## **ADDENDUM NO. 2**

Issued: October 25, 2016

Project: Joplin Early Childhood Center  
Site Legal Description:  
JOP MISC  
BEG 1360.93' S & 50' E NW  
COR SE E 456.91' N 318.78'  
W 456.91' S 318.78' TO POB

Project No. 16054

# A121C

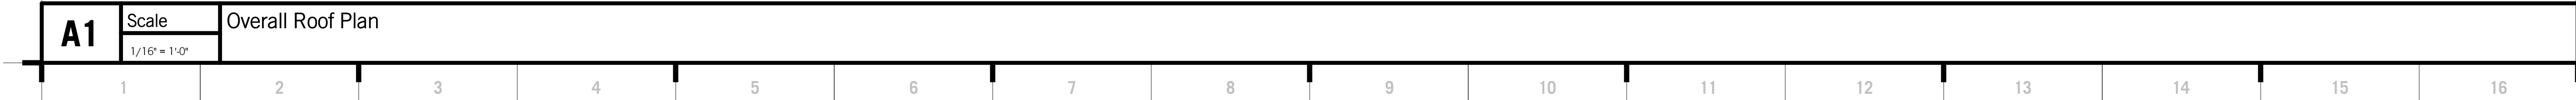
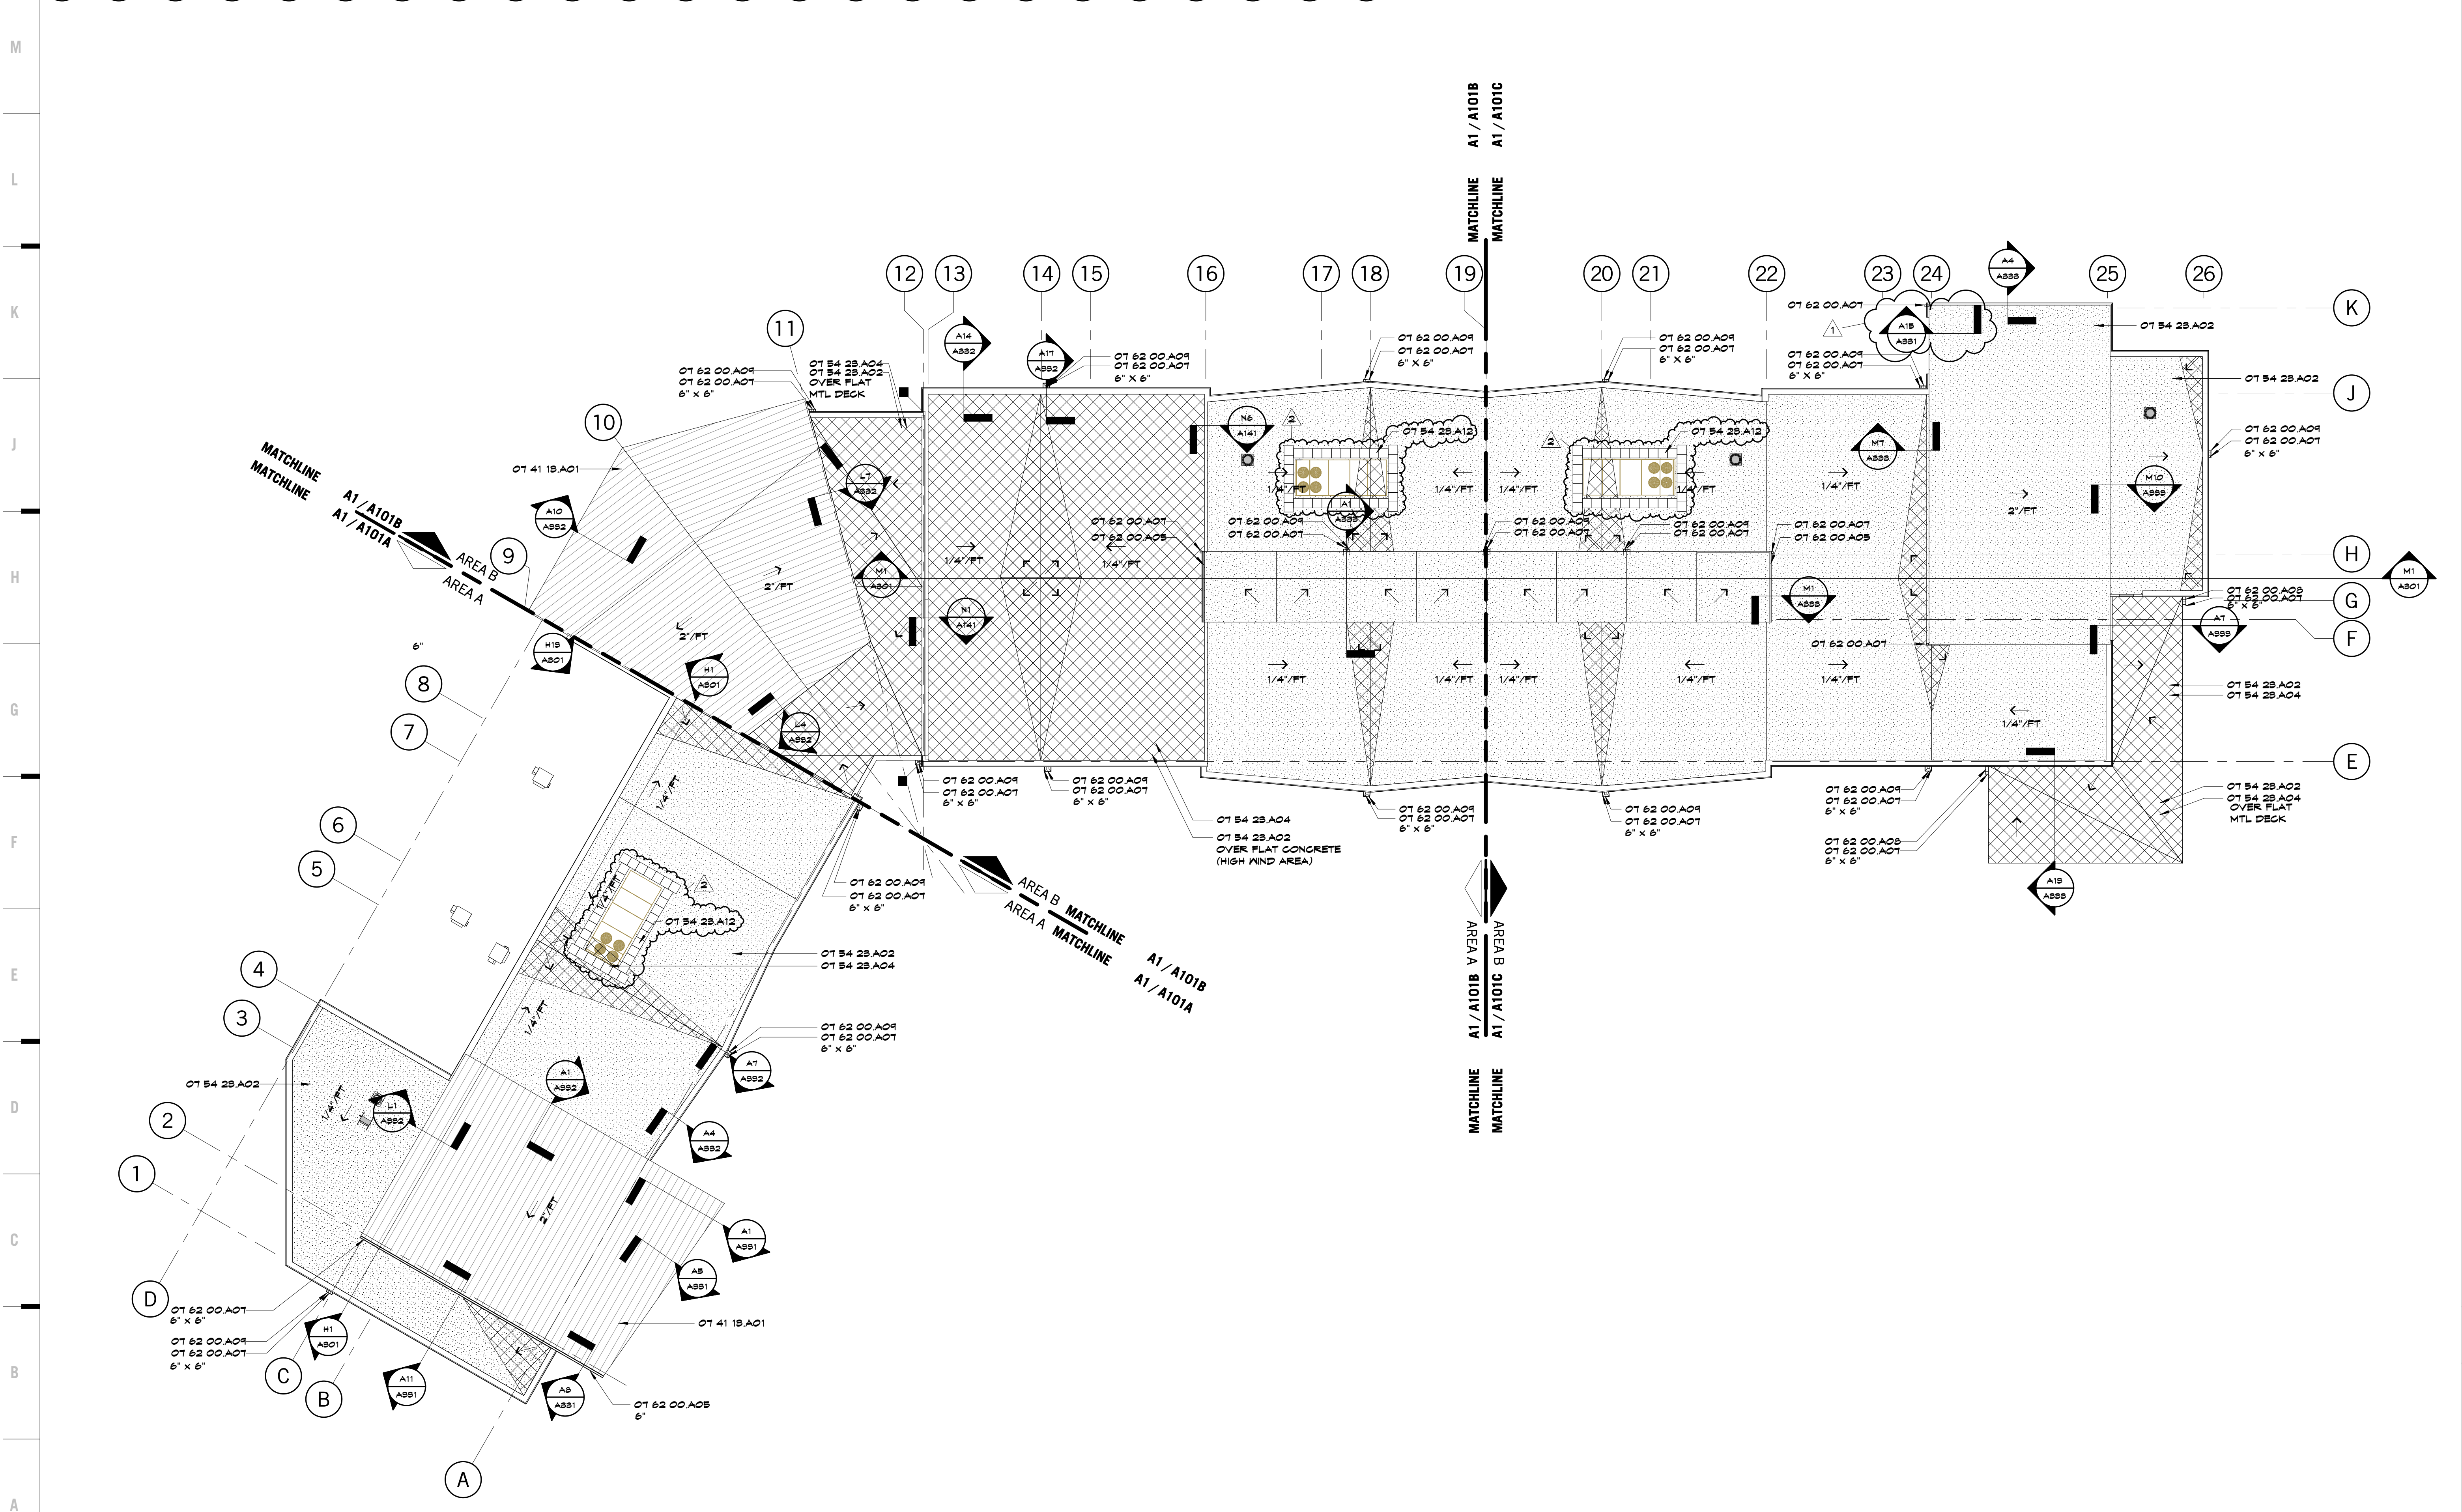
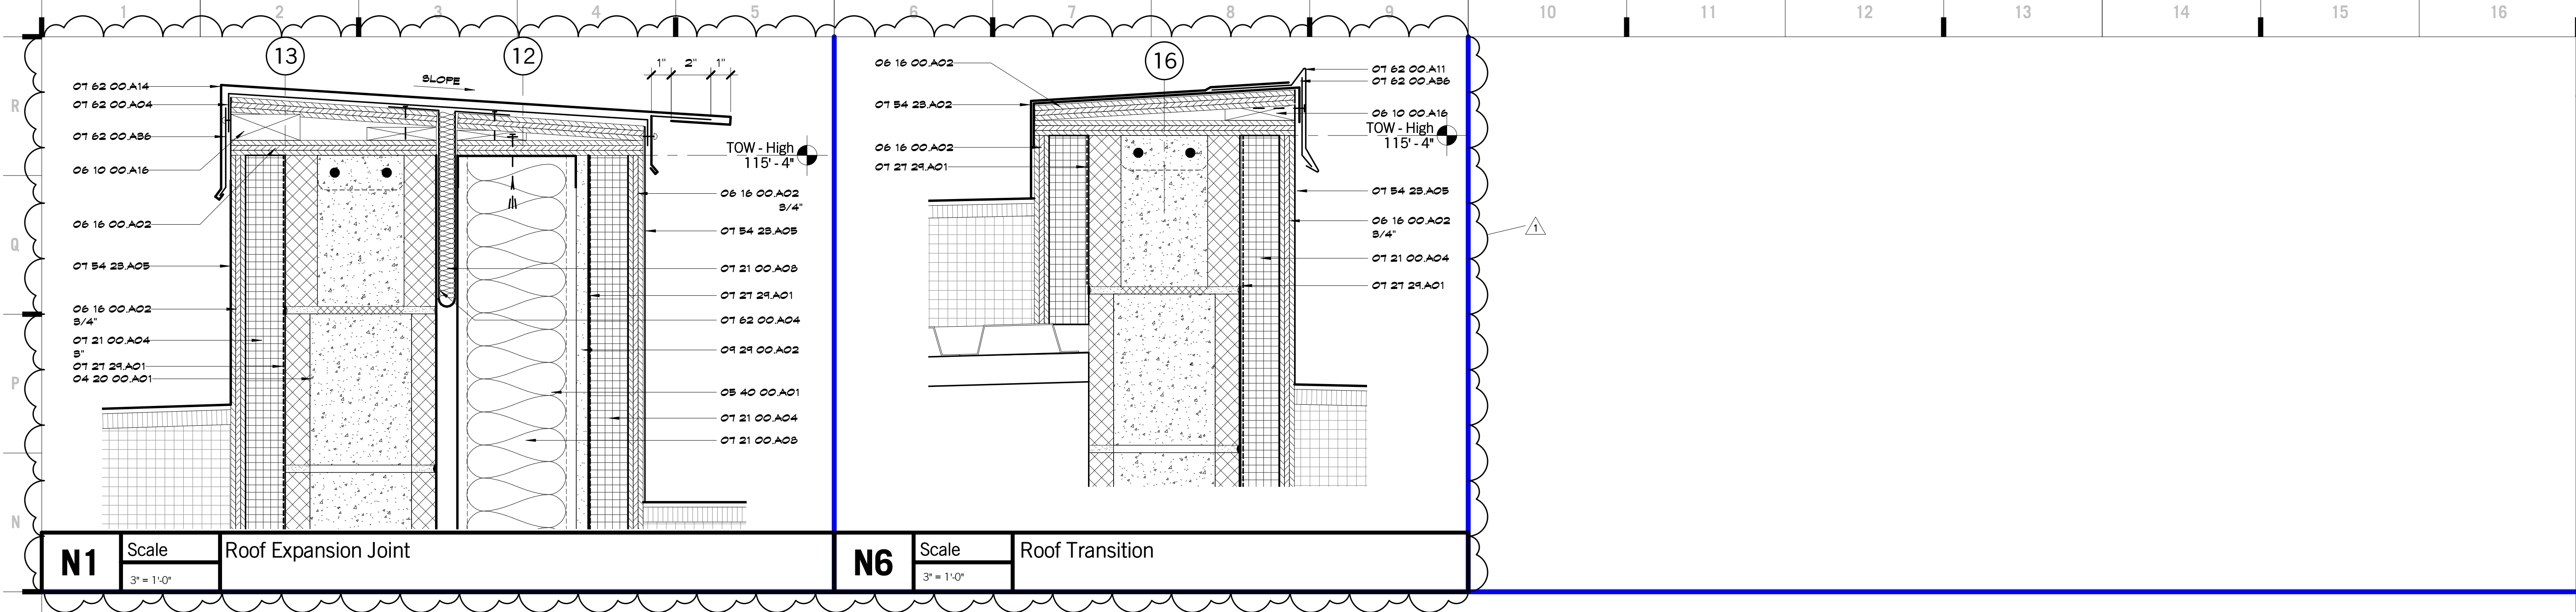
A21.1 REMOVE (3) PS1s to match enlarged plan on L7/A434.

A21.2 C101 Multi-Purpose – ADD ‘P9’ tag to gyp soffits

A201

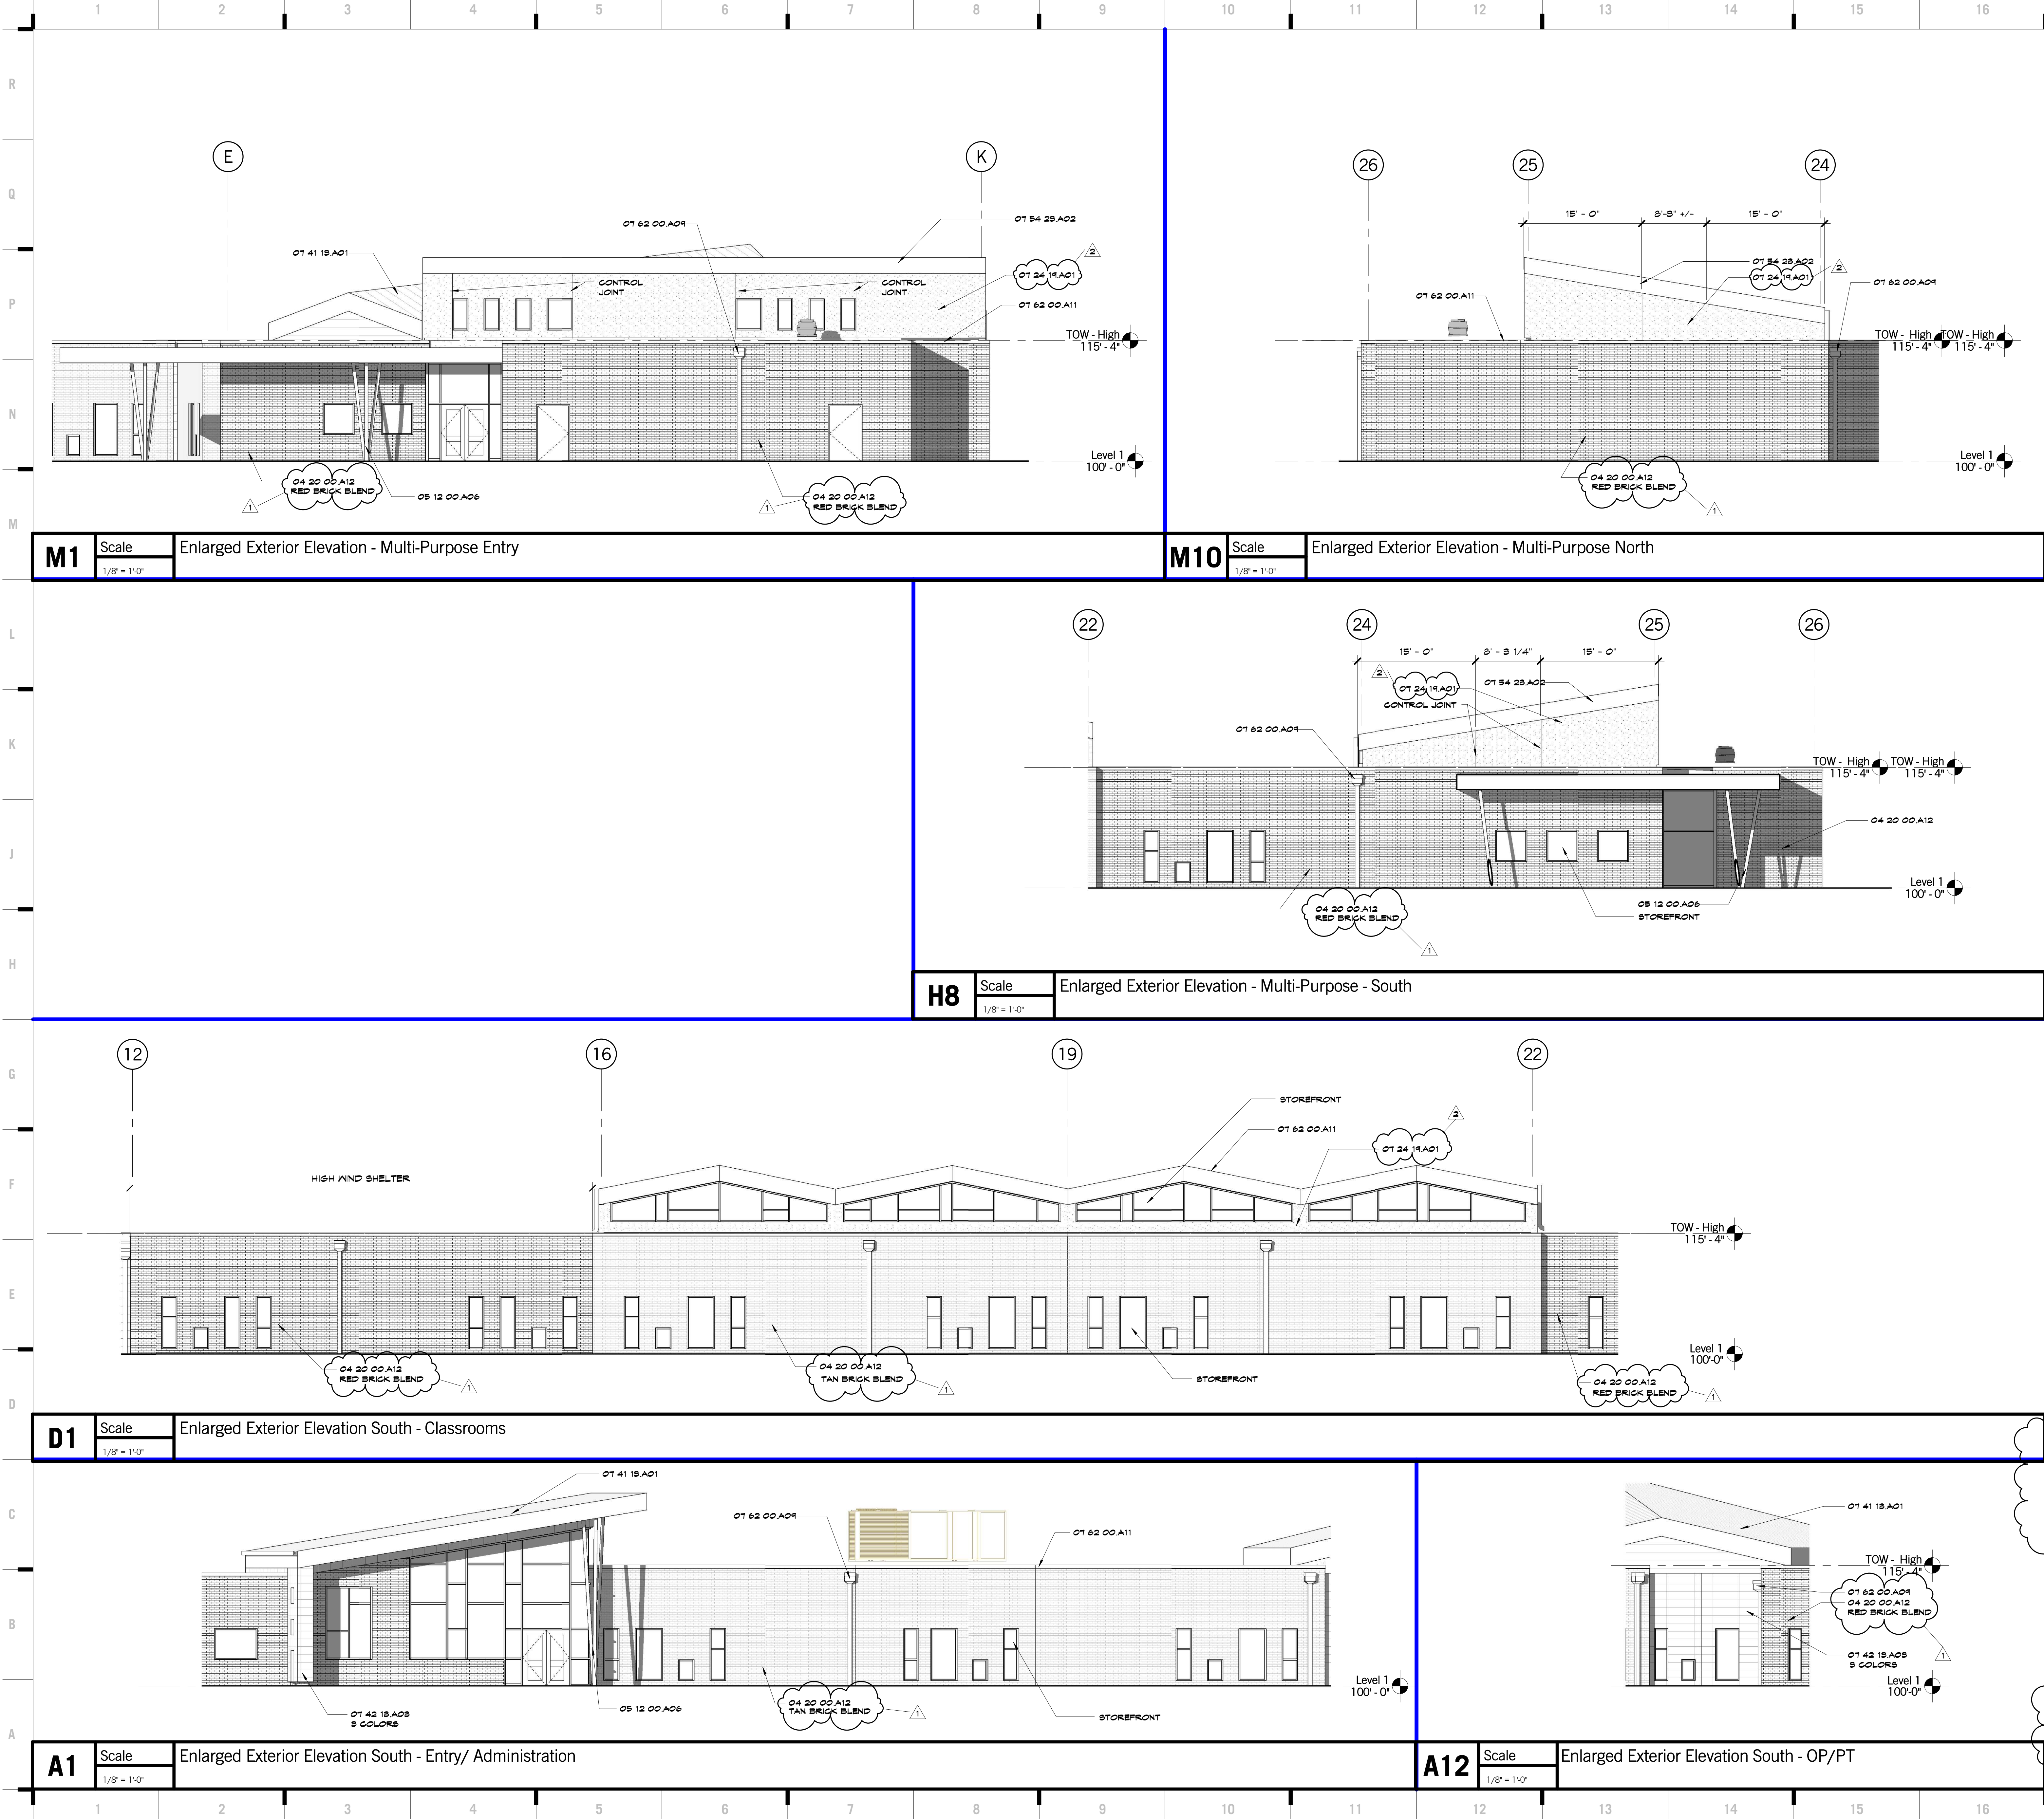
A23.1 REPLACE previously issued Sheet A201 in Addendum 1, with attached sheet A201 dated 10.25.2016. (Clarify EIFS system notes and custom aluminum sheet signage).
